PLANNING COMMISSION AGENDA

DR 04-09 / CUP 05-01 Canby Middle School - The applicant is requesting approval to construct a new Middle School on a 37 acre parcel located south of SE Township east of Trost Elementary School, currently zoned for residential development. Site plans propose to construct one middle school building with vehicle parking and bus transportation facilities. Site design also proposes construction of two soccer fields, two softball fields and one baseball field at the south portion of the site. The new school facility would accept approximately 1/2 of the current student body from Ackerman Middle School (initially estimated at 550 students). **Continued from 2-28-05** (materials to be delivered later)

TO: *Canby School District, BOORA, Planning Commission*
FROM: *John R. Williams, Community Development & Planning Director*
DATE: *March 3, 2004*
RE: *Canby Middle School Conditional Use and Site & Design Review issues*
CC: *Mayor Thompson & City Council; Mark Adcock; Darren Nichols; Canby Police; Canby Fire District*

design review discussion

1. Improved Fire and Police Access Around the Site.

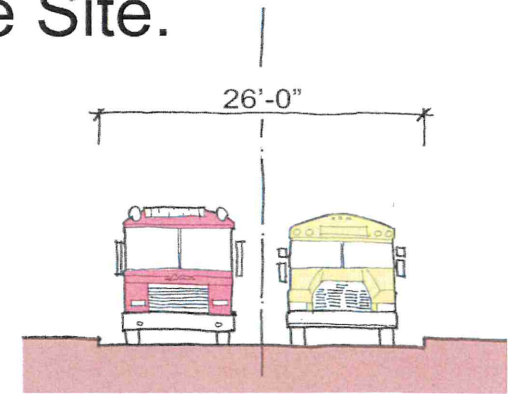
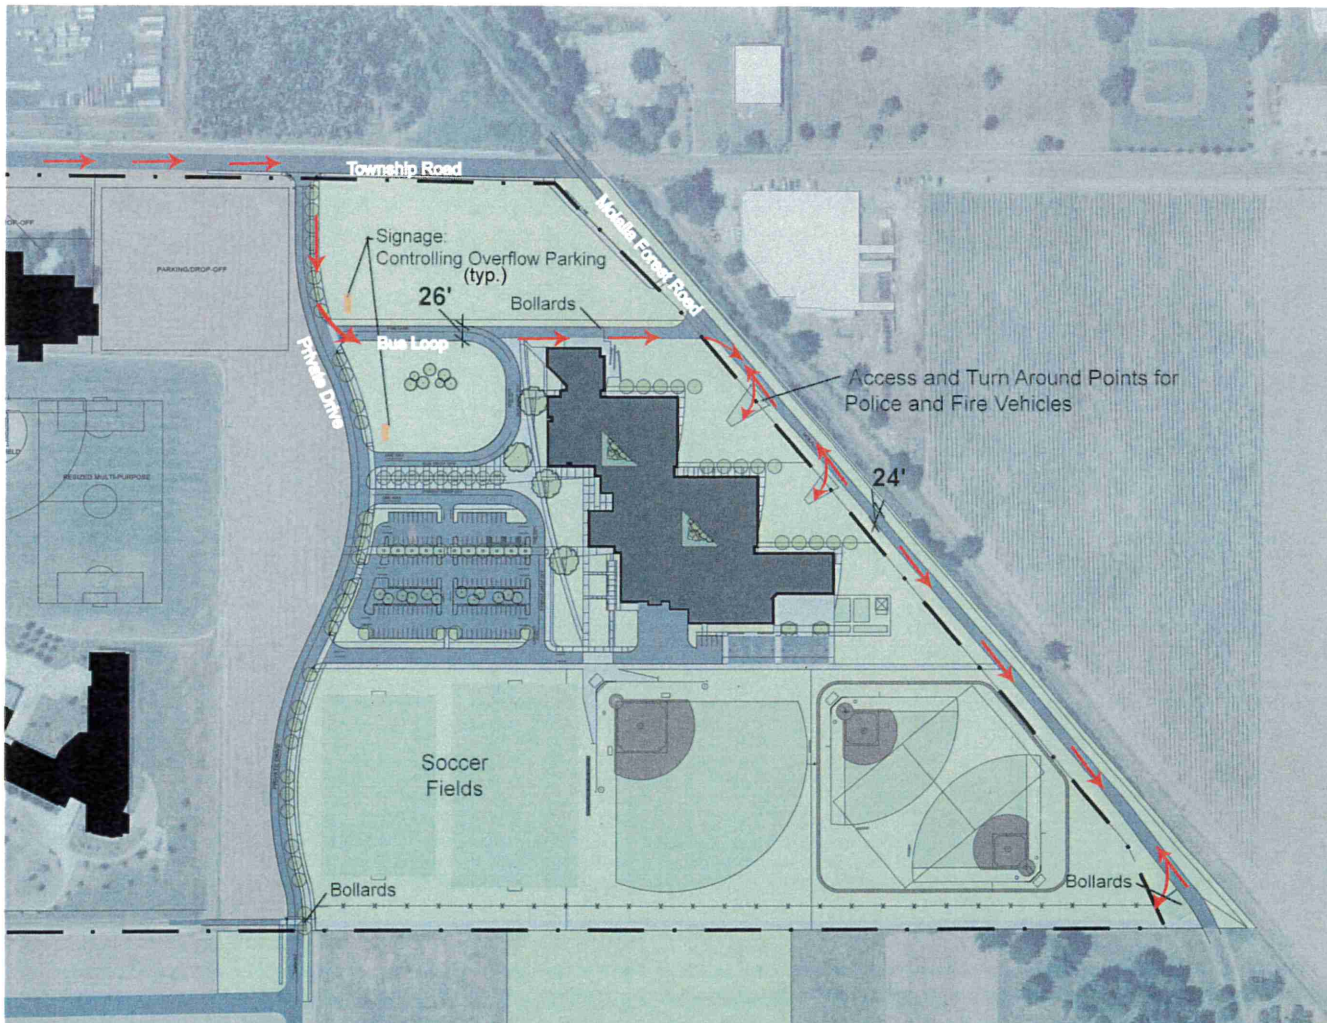
- 1. Improved fire & police access around the site.** The School District worked with the Canby Fire District in designing the site and the record contains responses from the Canby Fire District and Canby Police Department indicating services would be adequate. The Fire District felt that the Logging Road was adequate to serve the back of the site assuming the three proposed grasscrete fire accesses were installed. However, the Planning Commission felt that additional provisions were needed to ensure that medical services and police patrols could more easily access and monitor the far fields and east end of the site. I will talk to the Police Chief to confirm they are OK with their access to the site; perhaps the School District could talk to Ron Yarbrough and obtain additional documentation for the record on CFD's service plan for the site (specific issues I heard relative to CFD service were having to drive the wrong way to enter the northern access road, inadequate paved width on the Logging Road, and inadequate access to the SE field).

Section at Bus Loop

Section thru Molalla Forest Road

2. Lighting at Molalla Forest Road for Security.

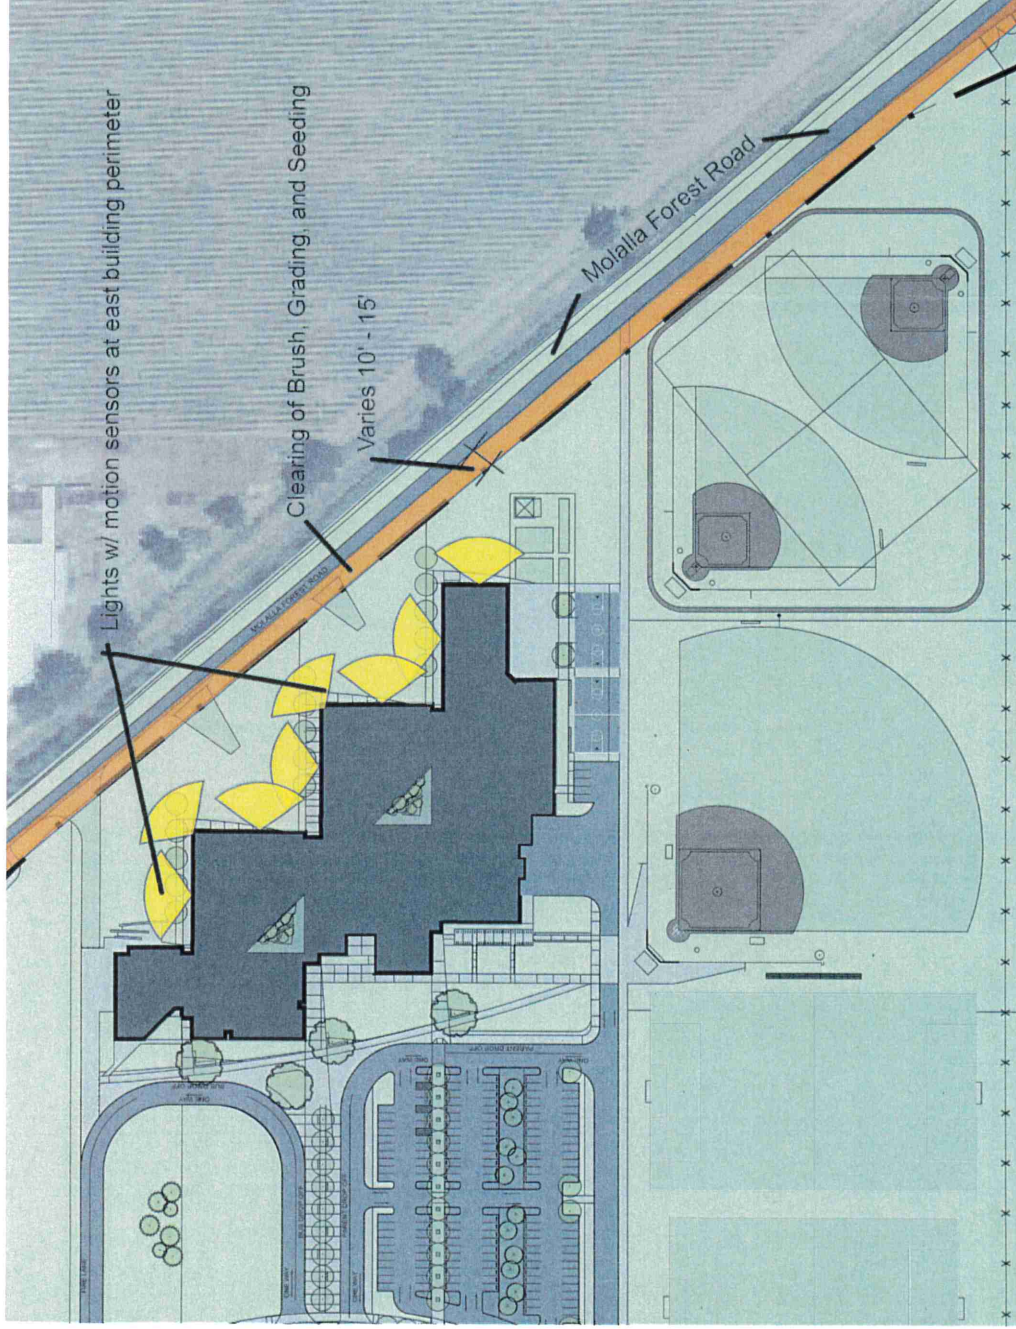
1. Improved fire and police access around the site.
2. Lighting at Molalla Forest Road for security.
3. Elimination of east-west pedestrian path at south property line.
4. (Dis)connection of vehicular access to Teakwood.
5. Additional parking for special events and sports.

Site Improvements at Eastern Property Line:

- Approx. 15' wide area btwn. property line and Molalla Forest Road to facilitate visibility, safety and supervision.
- Lighting w/ motion sensors on east side of building complies with code.
- Campus will be in "black out" condition after hours.
- Lighting of Molalla Forest Road is not part of Bond or Scope of Work.

4. (Dis)Connection of Vehicular Access to Teakwood.

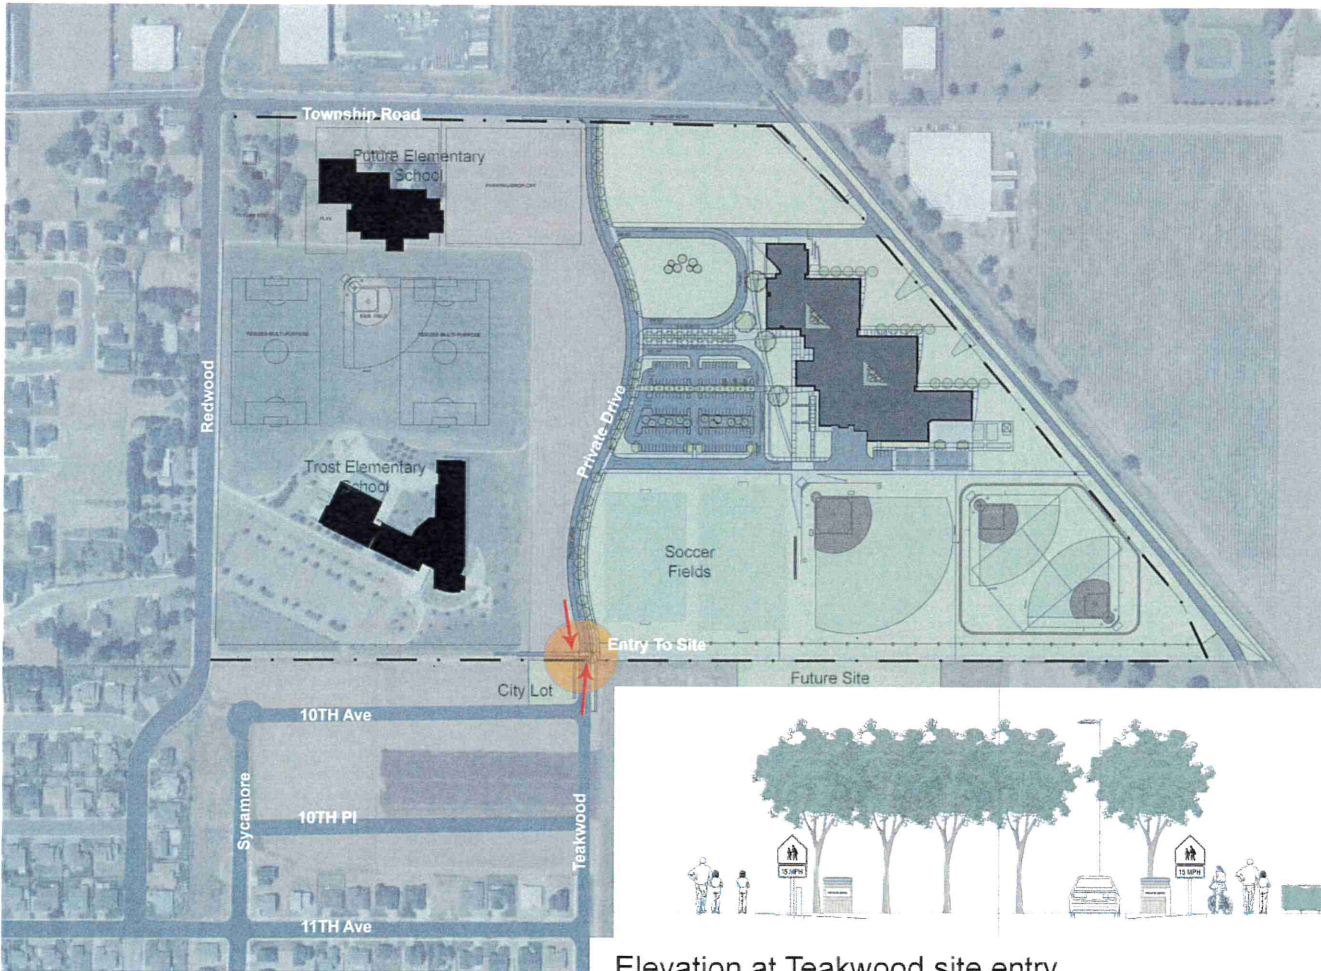
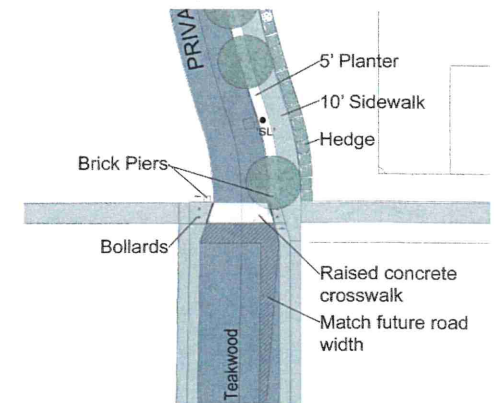
- 4. Disconnect the south access to S. Teakwood Street.** As I said at the hearing, this connection has always been part of the City's Transportation Plan. However, when the

- Follows City Master Plan
- Fire and Police Access from 2 Sides
- Logical Access to Site
- Even Distribution of Traffic

Design Solution:

- Emphasis on Private Drive
- Signage and Speed Limits (Traffic Calming)
- Raised Grade and Concrete Crosswalk
- No Gate Per City and Fire Marshal

5. Existing Parking Summary

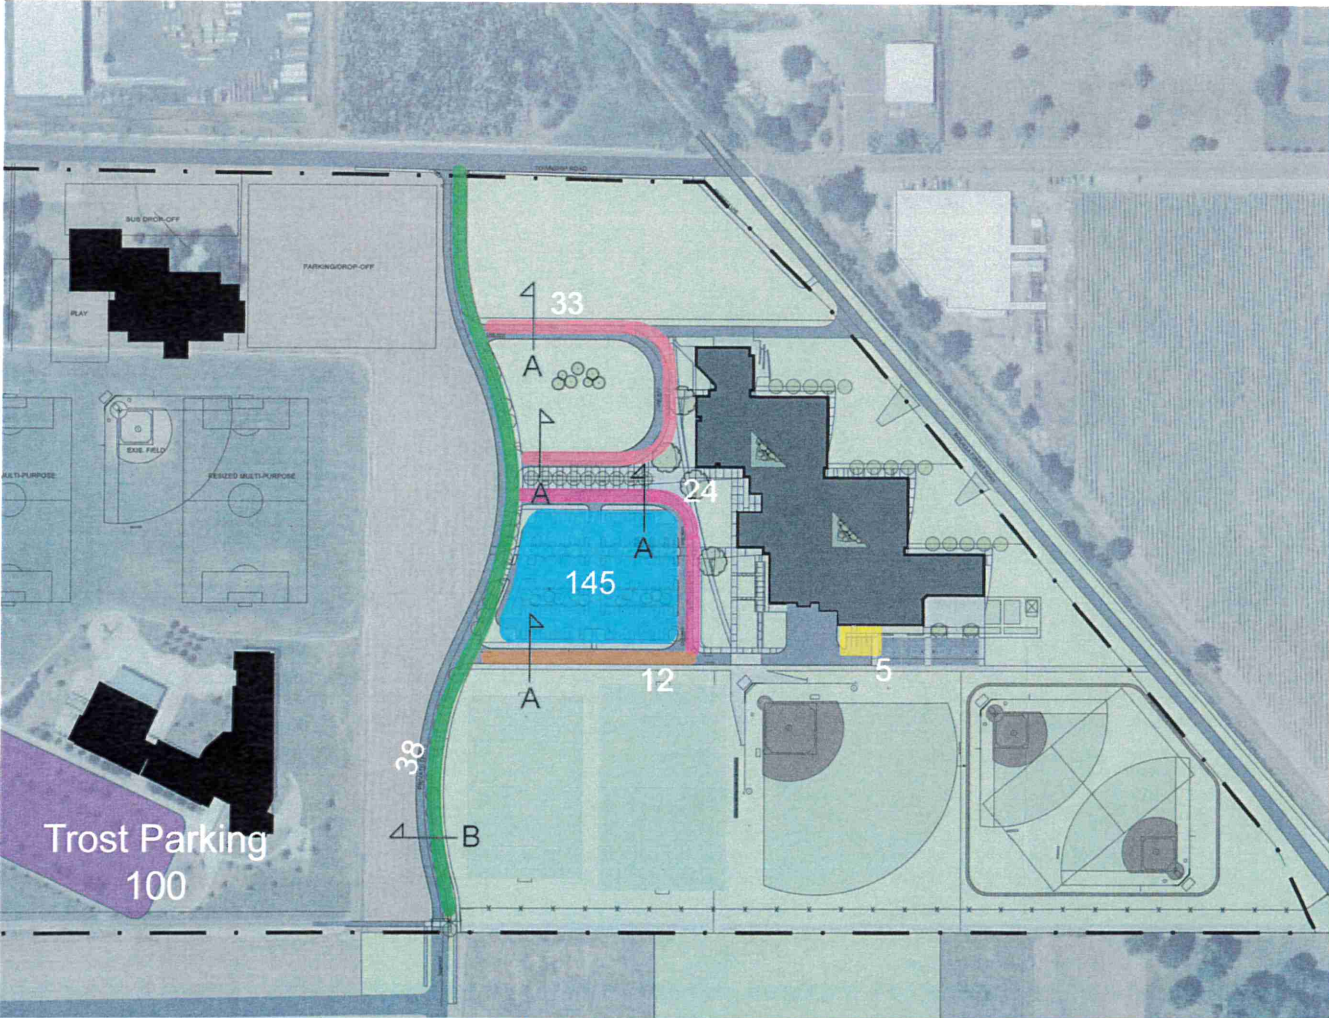
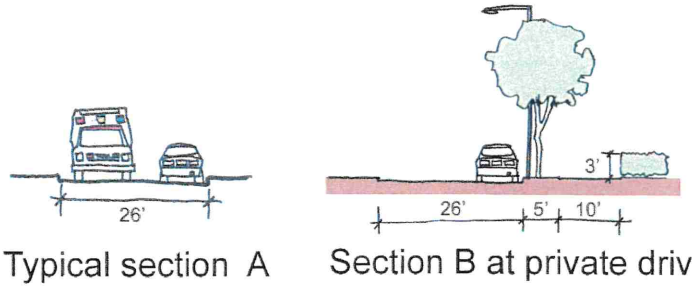
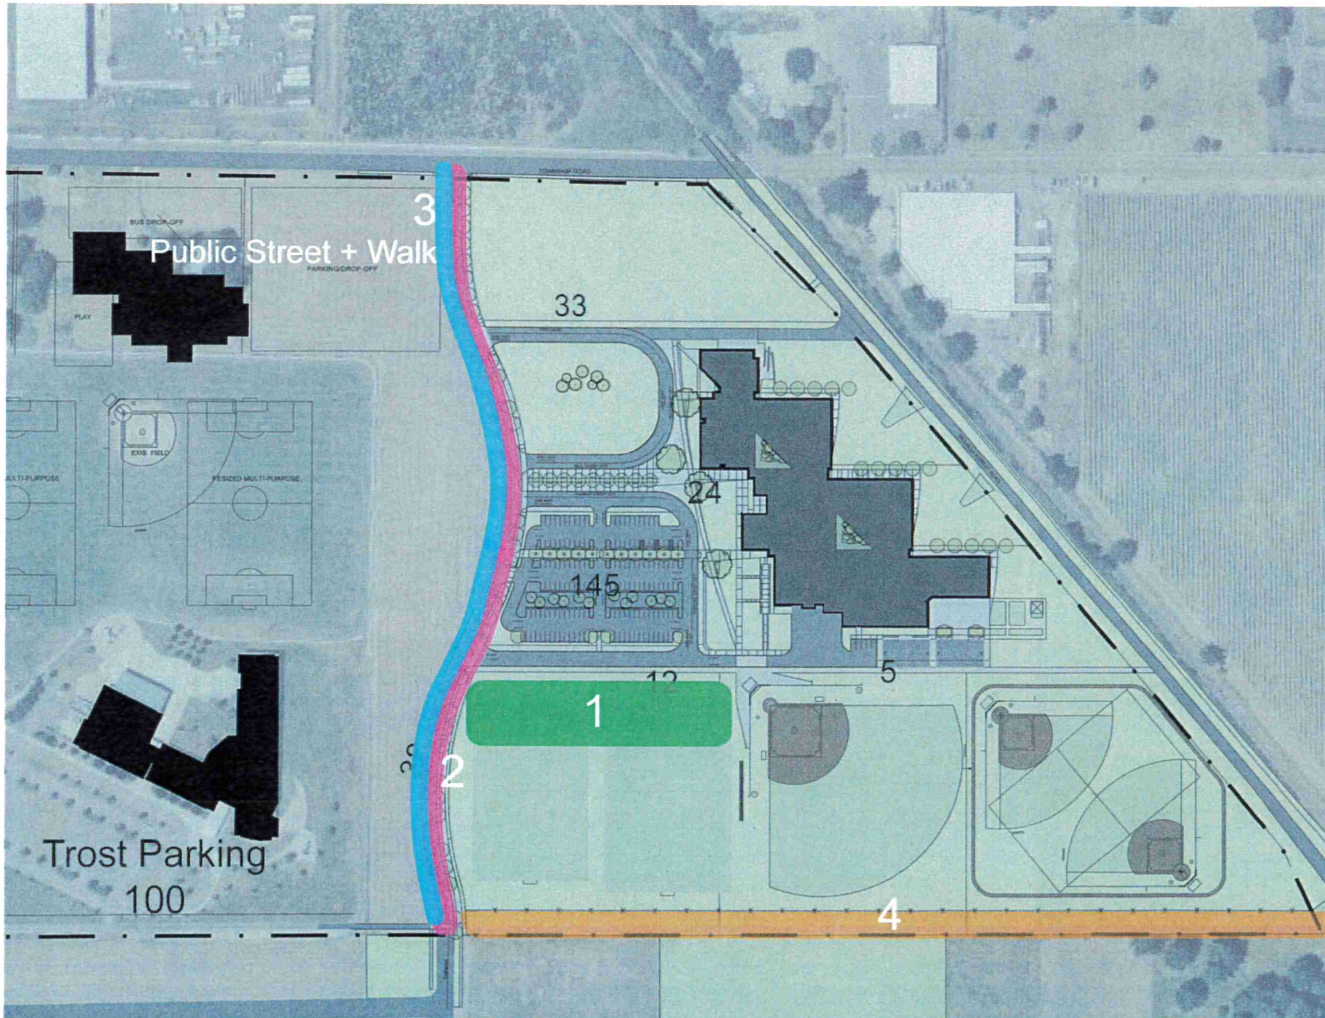
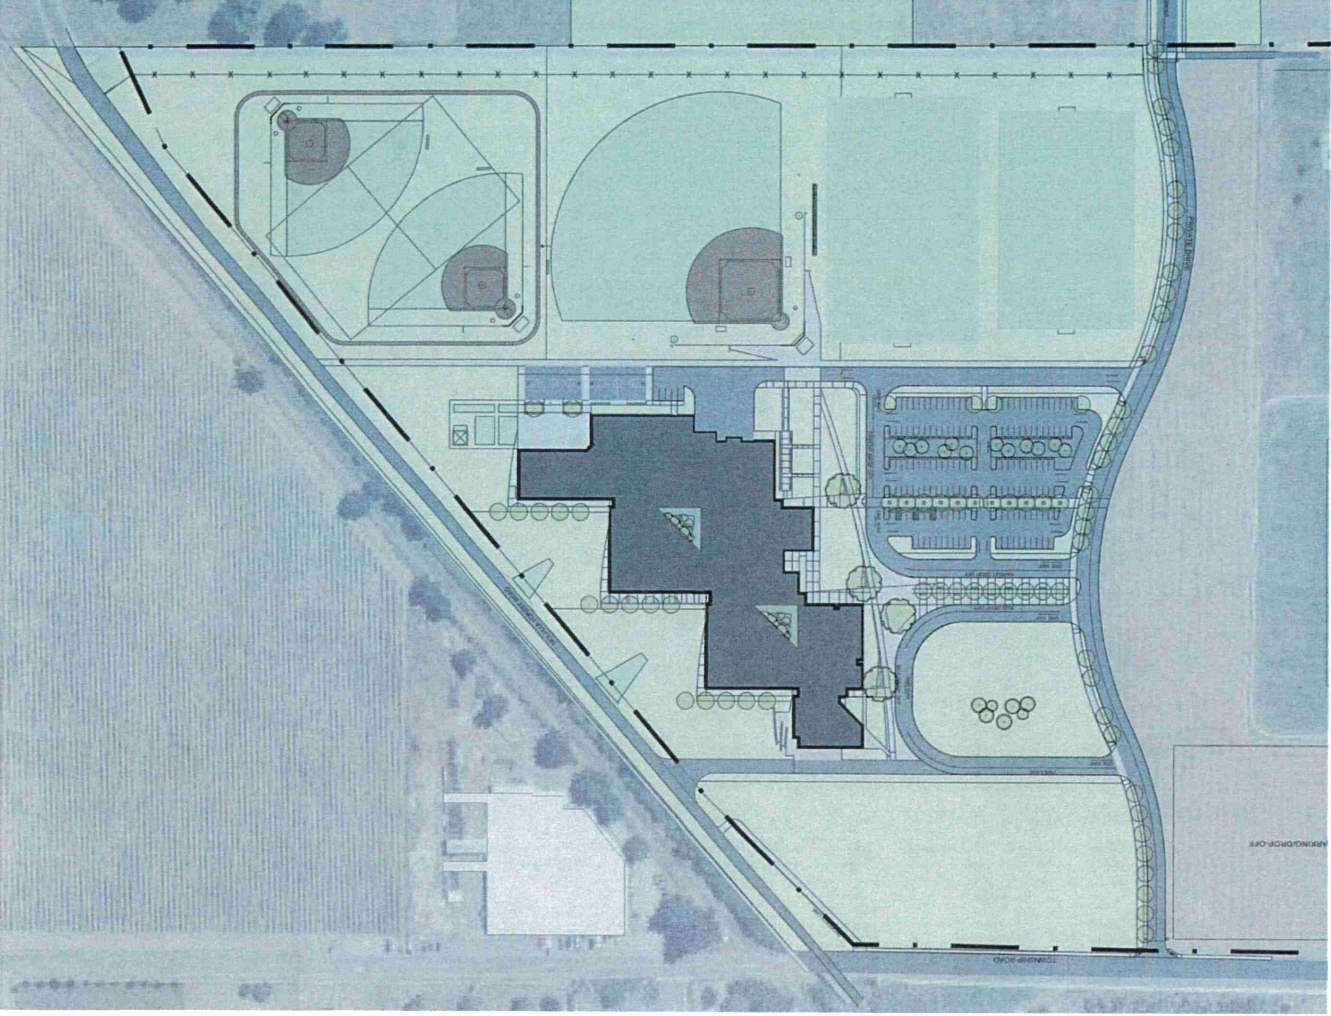
5. **Additional parking for special events and sports.** The School District is required to obtain a conditional use permit for this site, which requires the Planning Commission to make a finding that the use “will not alter the character of the surrounding areas in a manner which substantially limits or precludes the use of surrounding properties.” The record contains extensive testimony that special events and sports create traffic safety issues and neighborhood headaches at other sites in Canby, so the Commission would be hard pressed to find that the proposed design will not negatively impact the Faist neighborhood. Staff agrees with the Commission that the issue should be addressed.

It’s true that the proposed site design meets our parking code requirements for a middle school. However, the fields will certainly be used for community sports and the school will be used for community and special events, uses which were not really anticipated by our parking code when it was adopted years ago (it currently bases parking standards on the number of school staff using the site). The Planning Commission and Planning staff appreciate what our schools do for this community by serving as community gathering places. We also understand that the District’s financial resources are limited and are interested in finding a reasonable solution to this problem.

- e) Signing the bus loop, Teakwood driveway connection, and other drive areas for after hours parking. Staff likes this idea and recommends the school district provide details showing how it would work, how many spaces would be provided, how pedestrians would access these spaces, and how emergency service and other vehicle access would work if cars were parked in these areas.

Parking Summary

Main parking Lot	145
Parking near basketball courts	5
Signed parallel parking on private drive	38
Signed parallel parking on entry driveway	12
Signed parallel parking on parent drop-off	24
Signed parallel parking on bus drop-off	33
Total on Site	257
Trost off Site	100
TOTAL	357

1. 80 spaces	\$200,000.-	1
2. 62 spaces	\$70,000.-	2
3. 62 spaces	\$90,000.-	3
4. 168 spaces (gravel)	\$123,000.-	4
-includes \$31,000 credit

Final Design

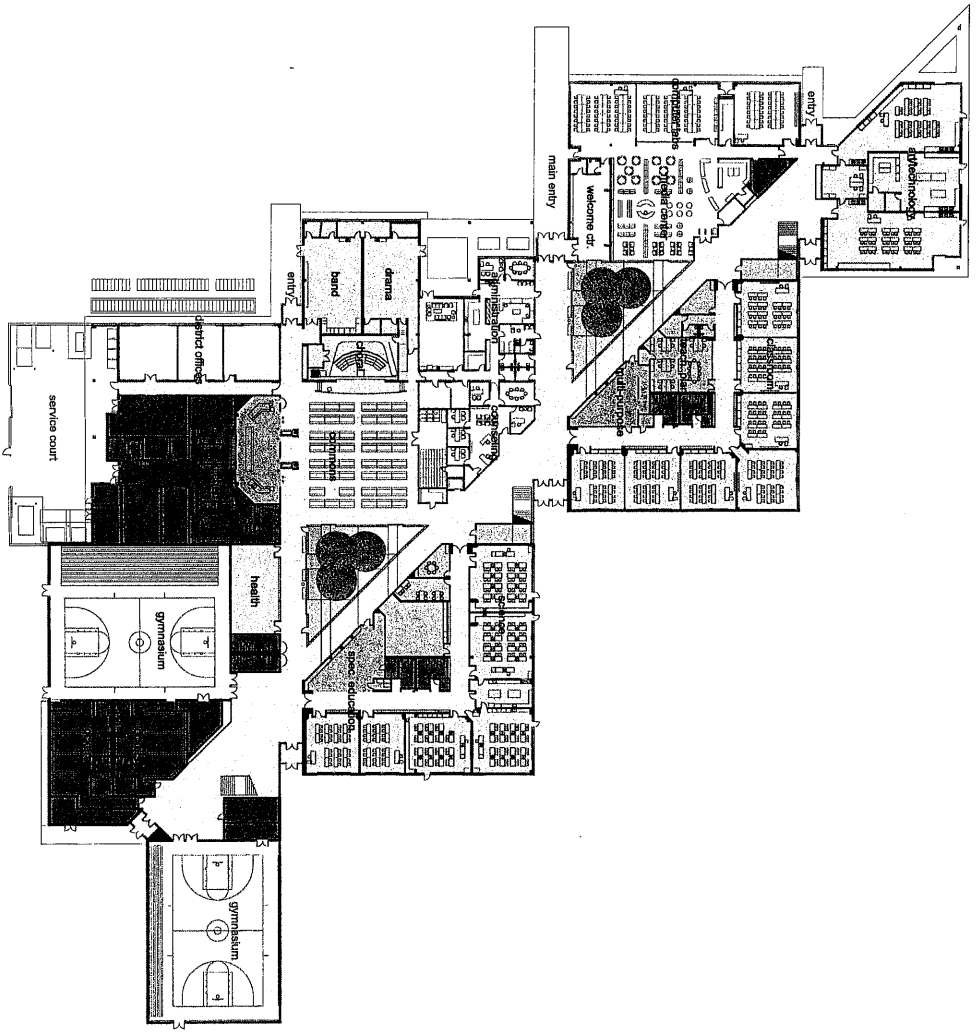
Finally, one note: it appears that the District has modified the site design since submitting the plans distributed to the Commission (these have a date of December 20, 2004). For example, the circular mound in the center of the bus loop has apparently been deleted and a pathway has been added from Township Road to the Logging Road. Once any changes are made in response to items 1-5 above, I would like a "final set" to be assembled and provided to the Commission and public.

Final Design Addresses:

- Fire and police access
- Improve lighting at east side of building
- Pedestrian path at south property line
- Appropriate connection at Teakwood
- Parking layout which exceeds requirements for middle school program and provides for special school events and sports
